# Planning Application with Navigation Implications: BESL – Piling Driving on River Chet

Report by Senior Waterways and Recreation Officer

This report provides members with a summary of officers' comments on the Environment Agency's recently submitted planning application for driving piles into the bed of the River Chet adjacent to the recently completed rollback floodbanks in Compartment 22 on the true right bank of the River Chet between Loddon and Nogdam End. Members' views on the report are welcomed.

Appendices: Appendix 1 Detailed drawings of proposals

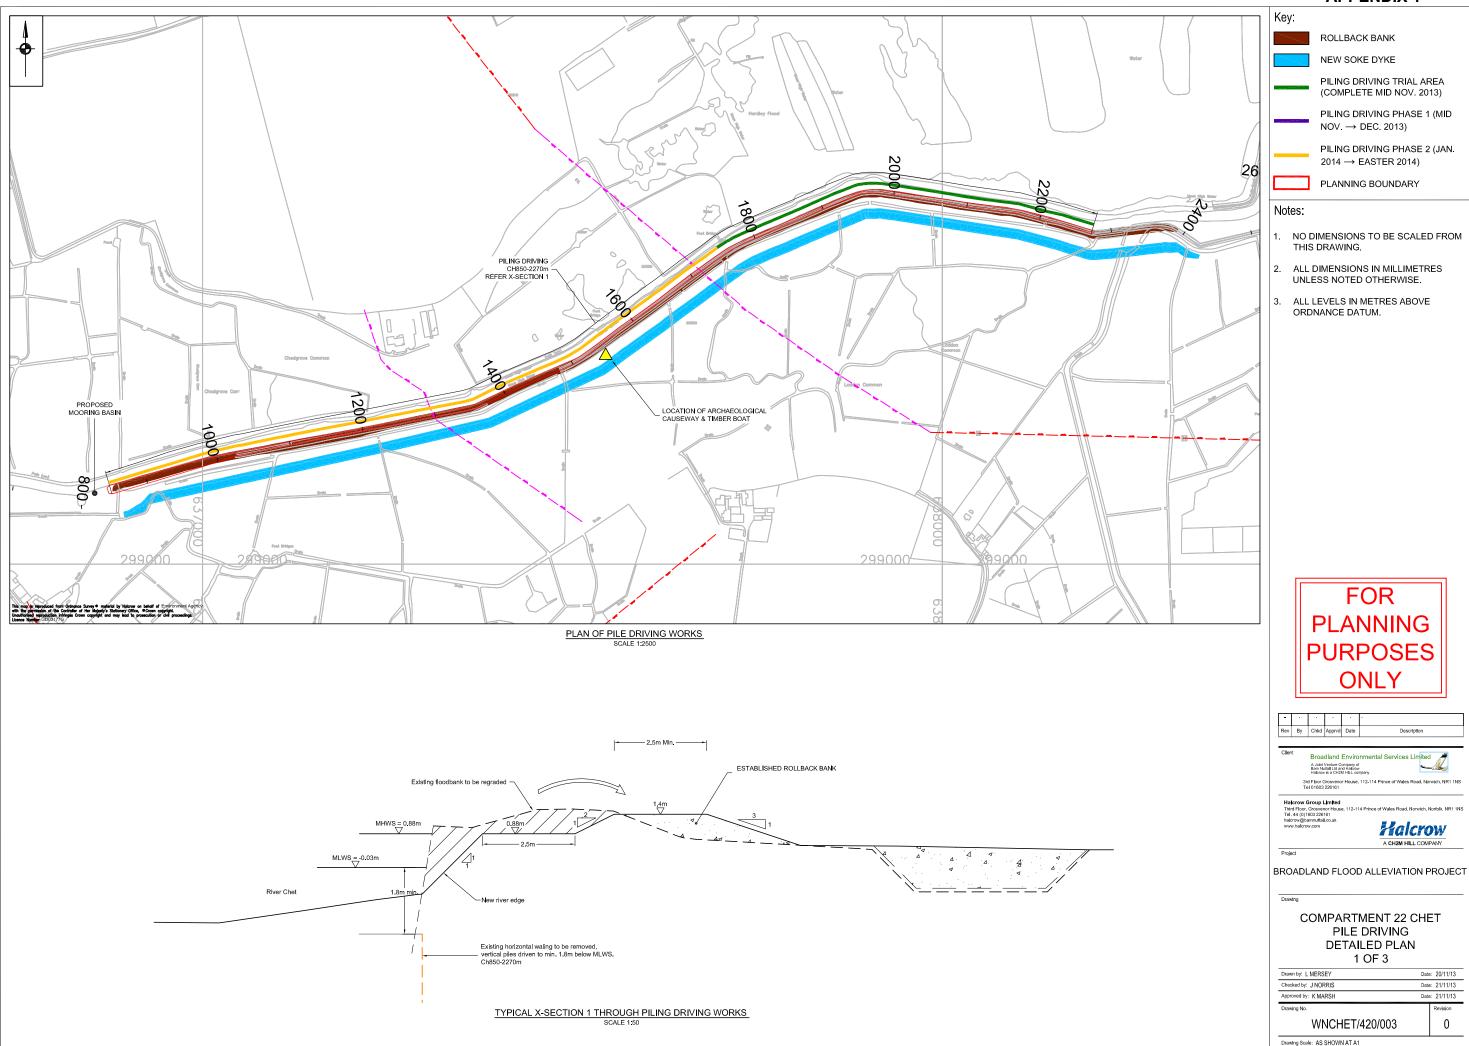
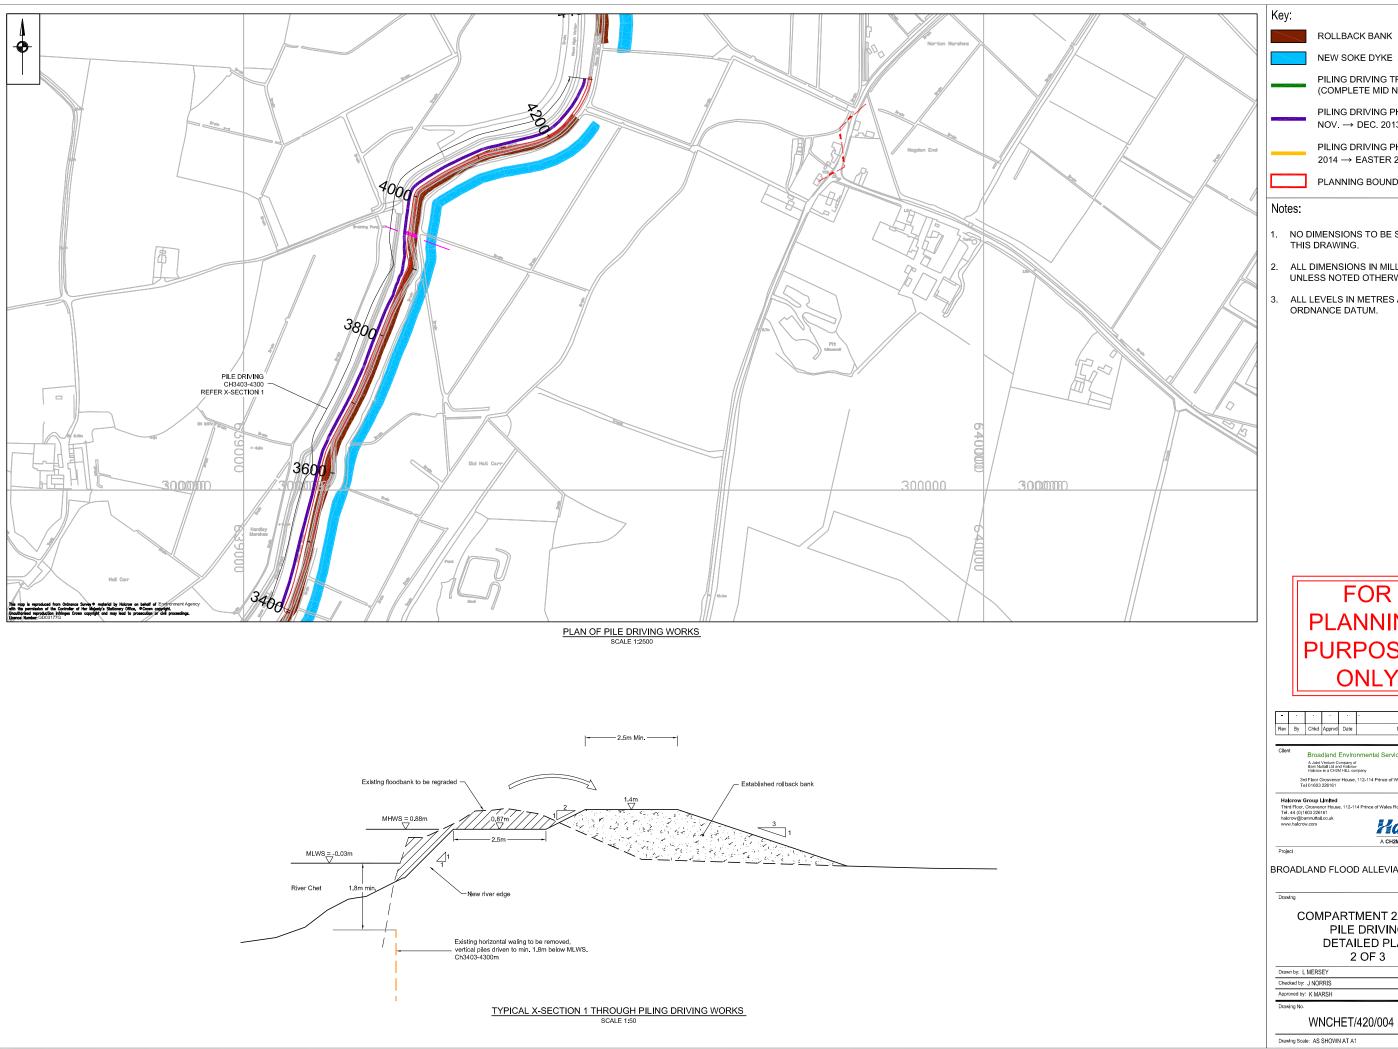
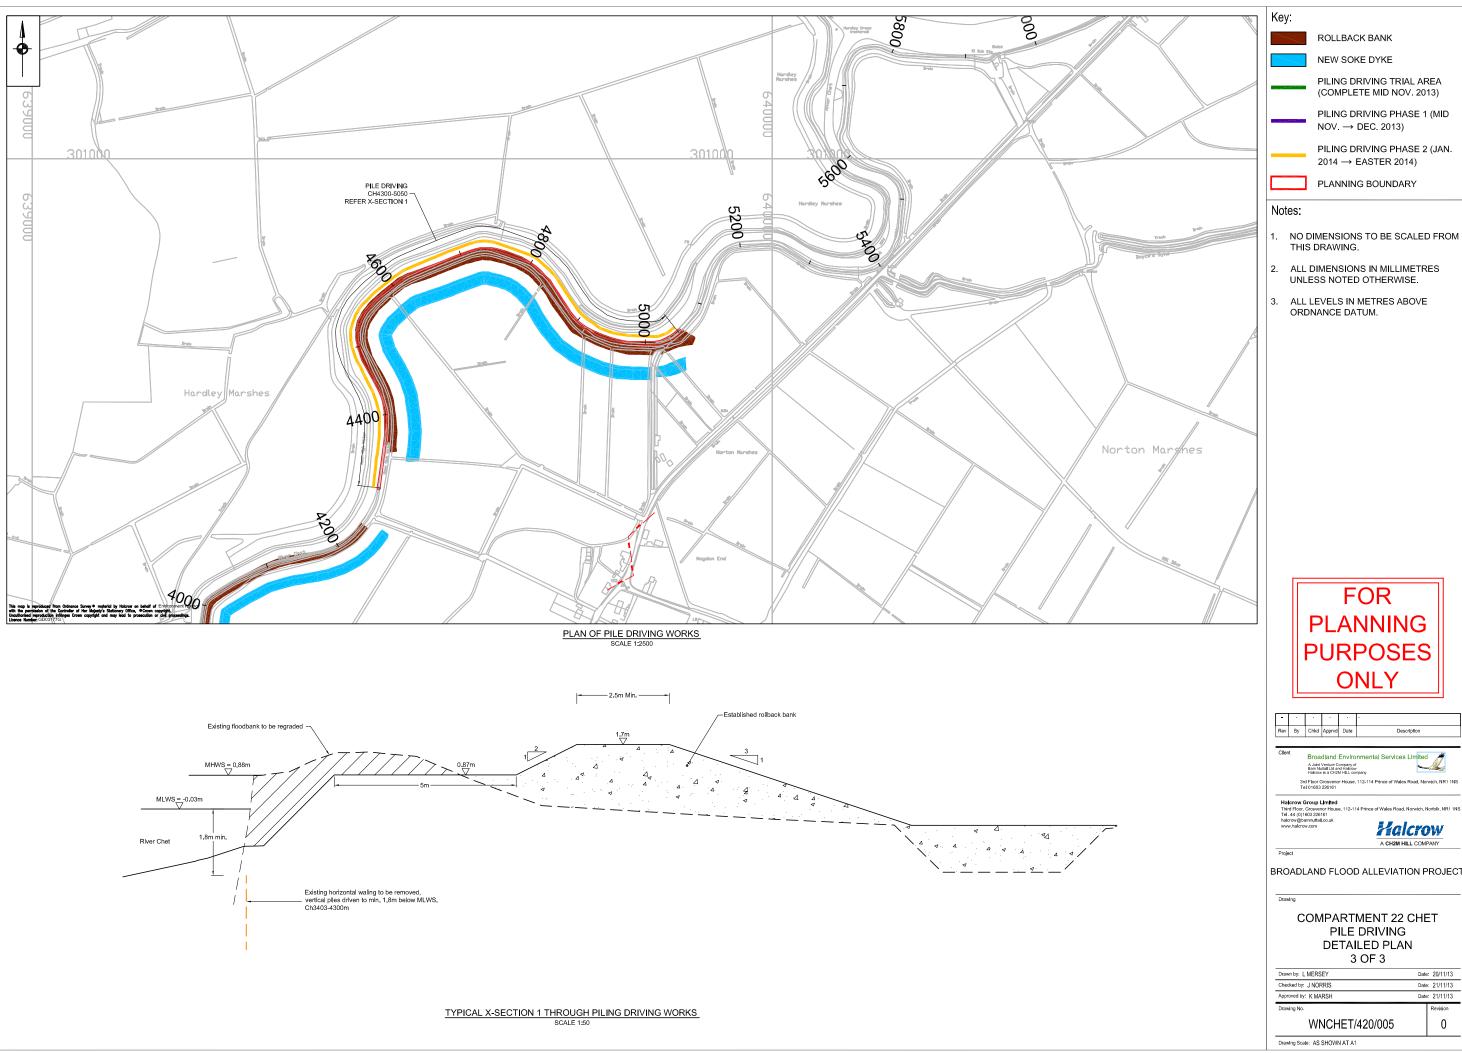
1.4 The pile driving trial was carried out in October 2013 and the EA has now submitted a part retrospective planning application for the works required to drive the rest of the piling in the compartment. The location of the proposed pile driving works is shown on the drawings at Appendix 1 to this report.

2.8 Officers consider that a driven top depth of -1.80mOD will be appropriate in most areas, however, it is noted that the bed of the River Chet can be up to 2.5m below mean low water (-2.55mOD) where flow is concentrated, for example, on the outside of bends and close to the inlets to Hardley Flood. This deeper water can be close to the bank particularly where it has been piled. Therefore it is important that the river depth is regularly monitored during the driving operation and if the bed level is found to exceed -1.55mOD officers recommend that the driven depth for the piles should be increased accordingly to at least 250mm below the existing bed level.

- 4.1 First, and key to the success of the proposed works, it is recommended that a condition should be placed on any planning permission granted by the Authority requiring a BESL to carry out a full survey of the actual bed level of the river in order to establish a baseline for comparison with further surveys and enable appropriate depths for pile driving to be identified. Depending on the results of the survey further conditions should be placed on any planning permission granted requiring piles to be driven to the following depths:
  - a. where the bed level is above -1.55mOD (BA dredge spec), piles should be driven to a top level of -1.80mOD);
  - b. where the bed level is below -1.55mOD (possible on outside of bends and close to Hardley Flood inlets), piles should be driven to 250mm below existing bed level.
